Groundwater modeling analysis

Jack Wittman
Vic Kelson
Layne Christensen Company for Abengoa Solar
January 15, 2010

Model development for data request

2042 difference results

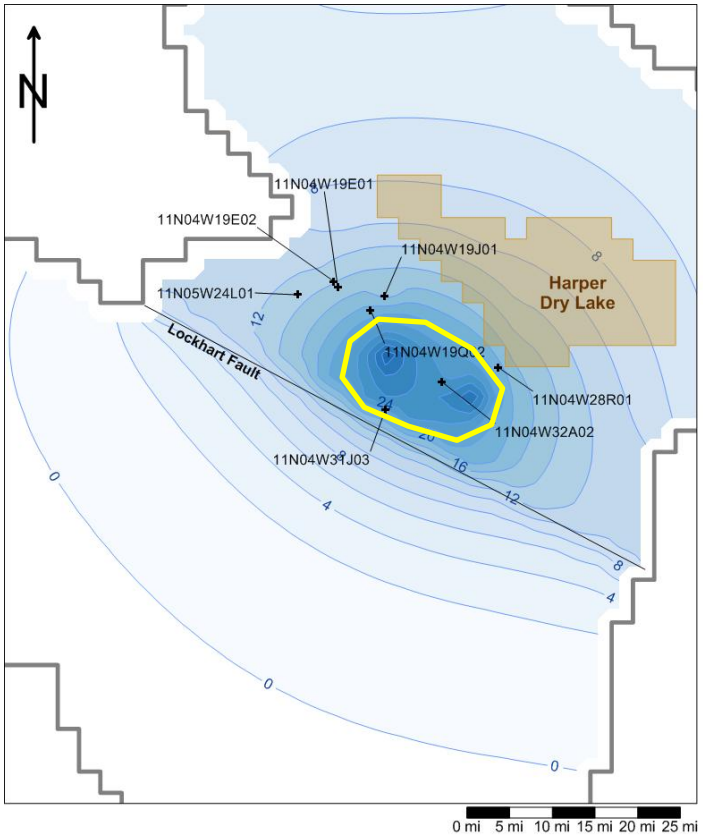
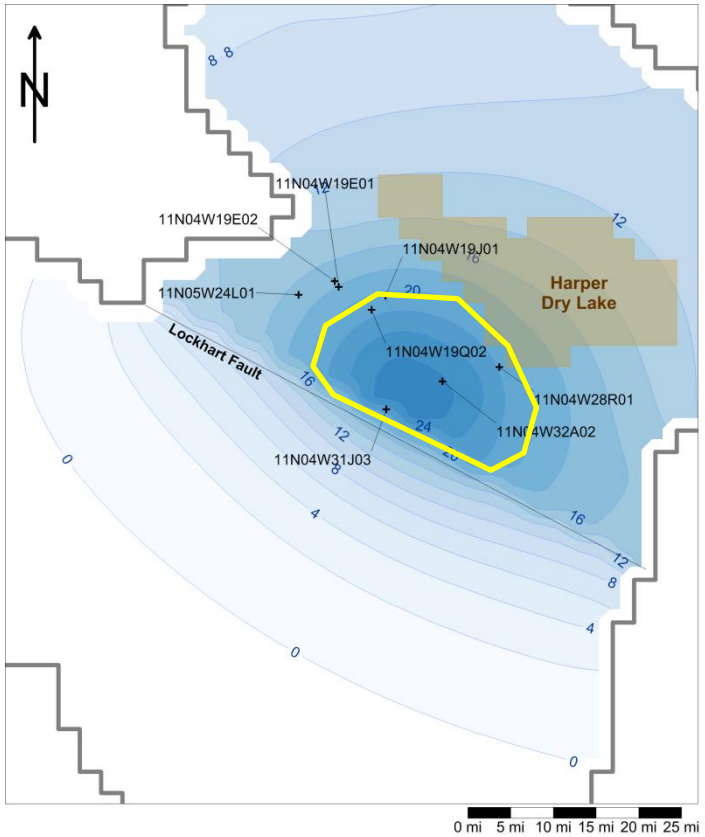
- Review of the updated USGS model identified two issues related to the conversion of the Stamos model
  - The steady-state 1931 model files included a 60 cfs recharge well (the text of USGS WRIR 01-4002 reported 10 cfs)
  - The first stress period length was improperly converted by Groundwater Vistas
- Neither of these issues were expected to significantly change the model results
- The change to the steady-state 1931 model only affects initial conditions for the transient predictive runs

Corrected 1931 initial condition

Pathline analysis for 1931 ambient conditions; 1000 years between dots

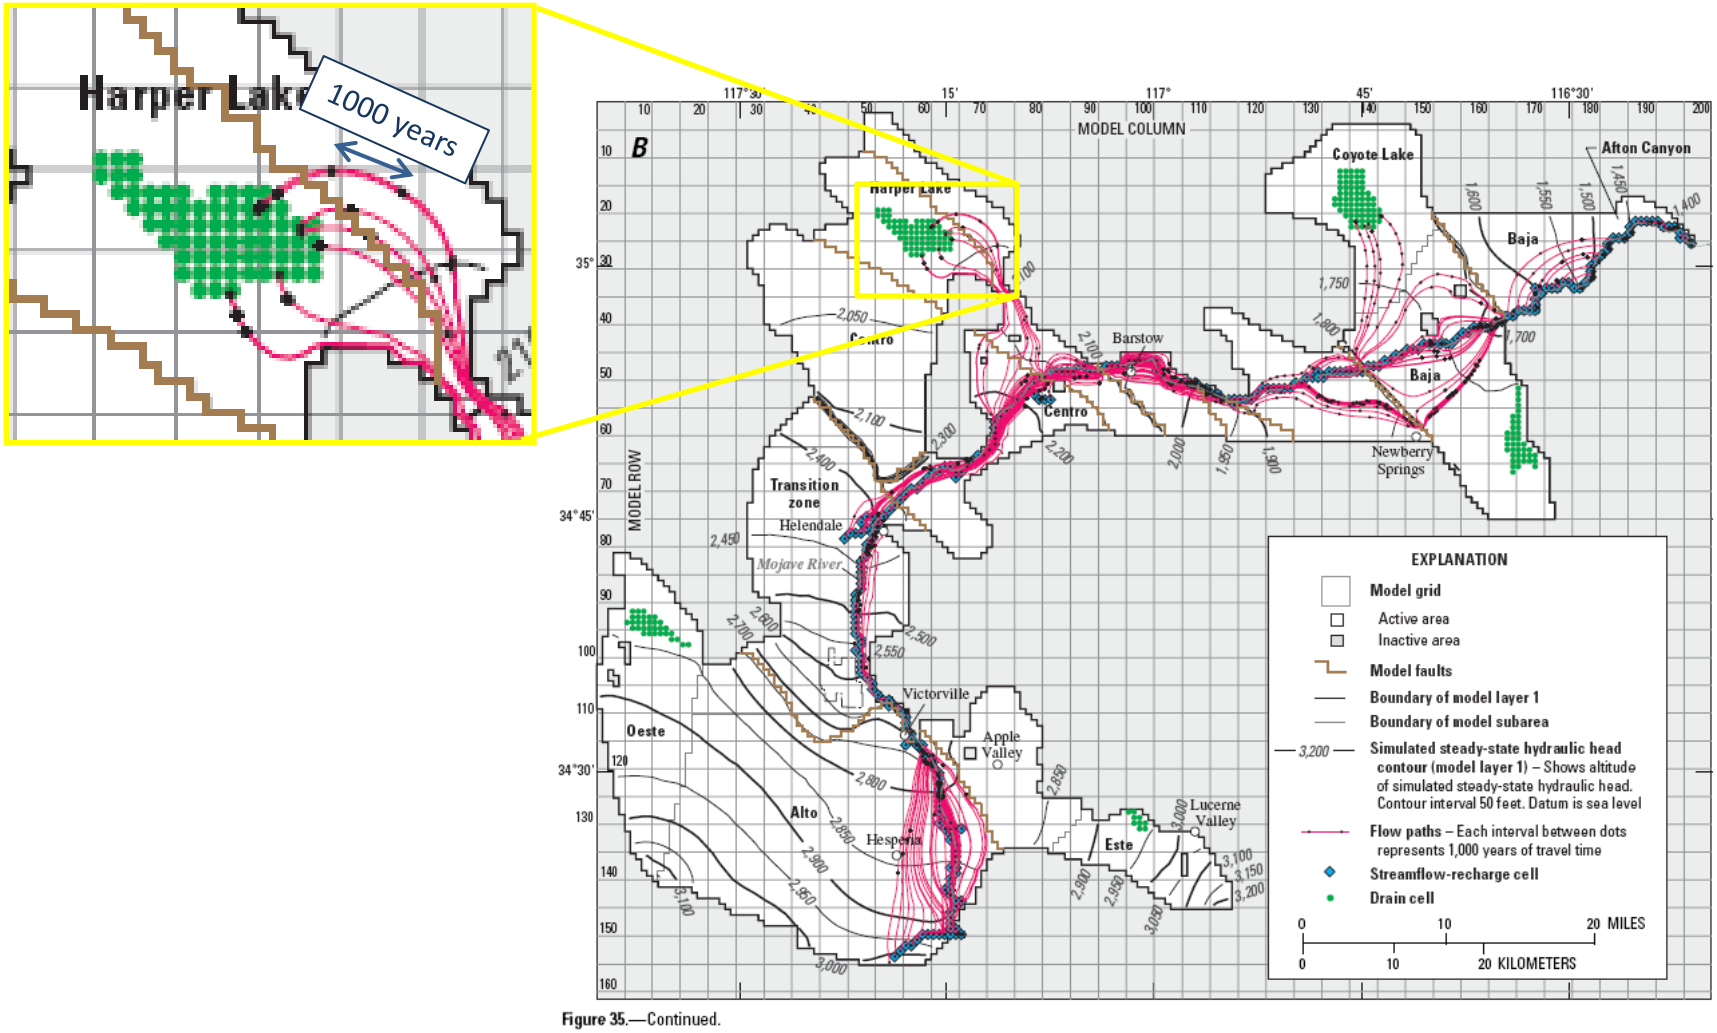
- CEC requested that the pathline plot for groundwater travel (Figure 22 A-2) trajectories from Harper Dry Lake be modified to identify travel times
  - Model has been modified
  - Internal errors from Groundwater Vistas have prevented completion of this task at this time
  - We will respond as soon as possible
  - We provide the Stamos travel time plot for comparison

In the 1980s, nearby measurements ranged from 1133-1307 mg/l

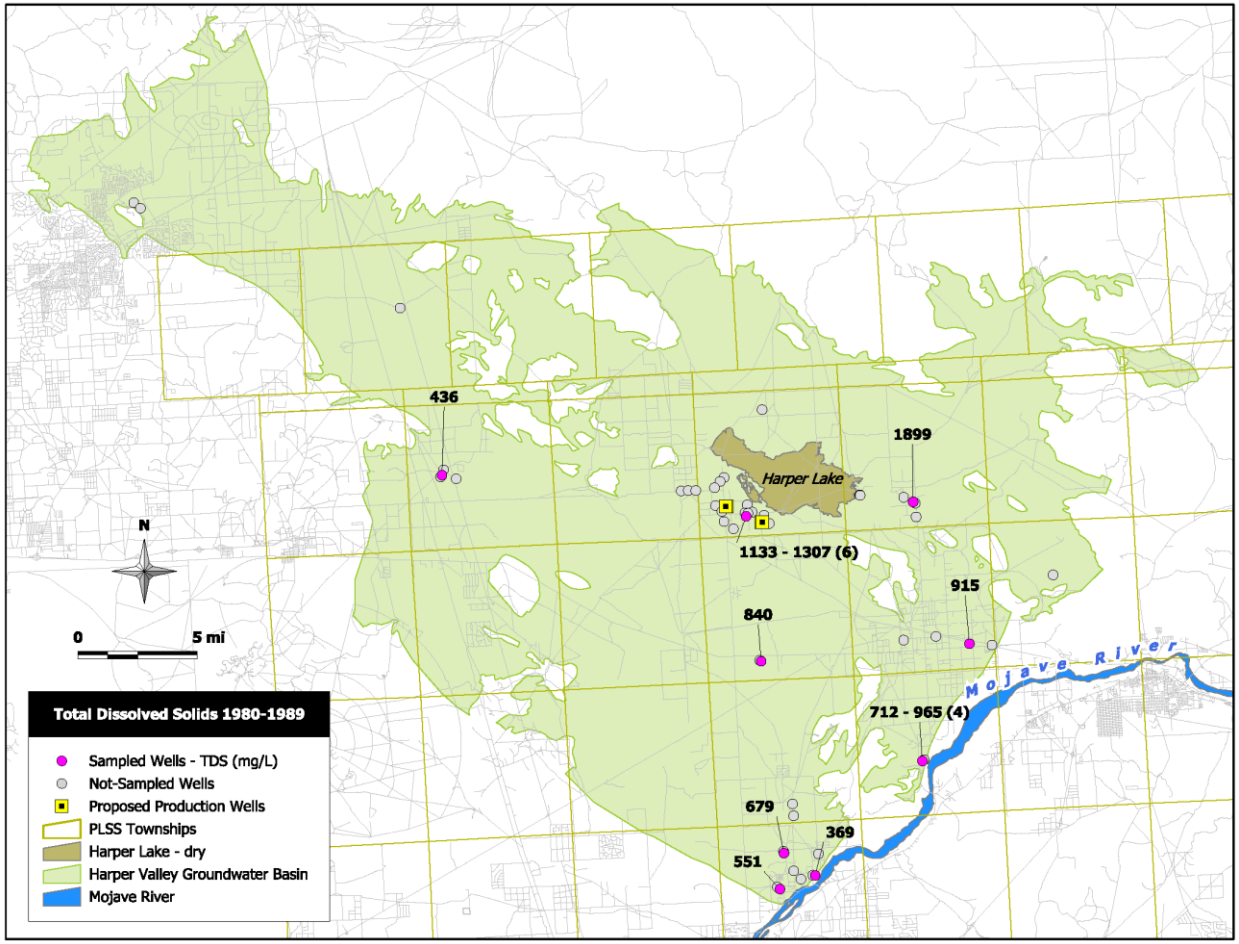
- CEC requested specific predictions of TDS in the Abengoa wells
- Major concern was whether TDS exceeds the 1500 mg/l threshold
- We examined the available data for three decades: 1980s, 1990s, 2000s
  - Summarized the range of measurements at specific wells over each decade
  - Superimposed the summary on a map of HVGB
